15 Clover Avenue Official Plan and Zoning By-law Amendment Applications City File OR01/20

Ramsay Planning Inc.

Figure 2 Existing and Proposed Front Yard Setbacks

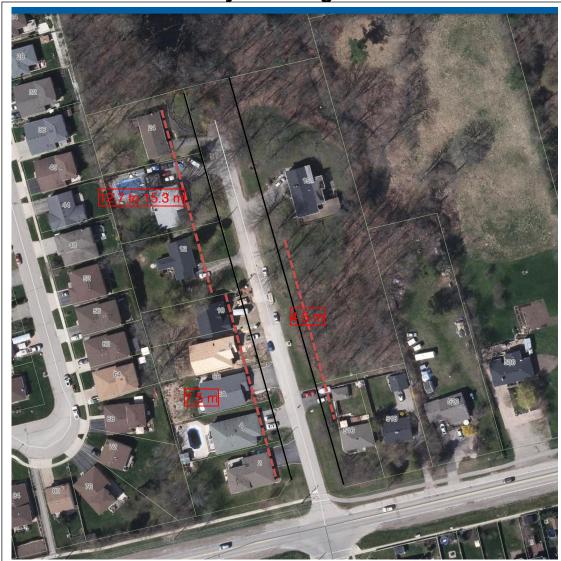
- Proposal does not conform with the City OP that requires infill and intensification to respect and be compatible with neighbouring land uses.
- Proposal is an overdevelopment of the Site.
- Scale and massing that is out of character for the area.
- The proposed development will dominate the streetscape, dwarfing the homes along Clover Avenue.
- The reduced setbacks and building separation will worsen, rather improve transition to adjoining uses.
- The site is suitable for some intensification, but not the extent proposed by the Applicant.
- I recommend that the Applications not be approved.
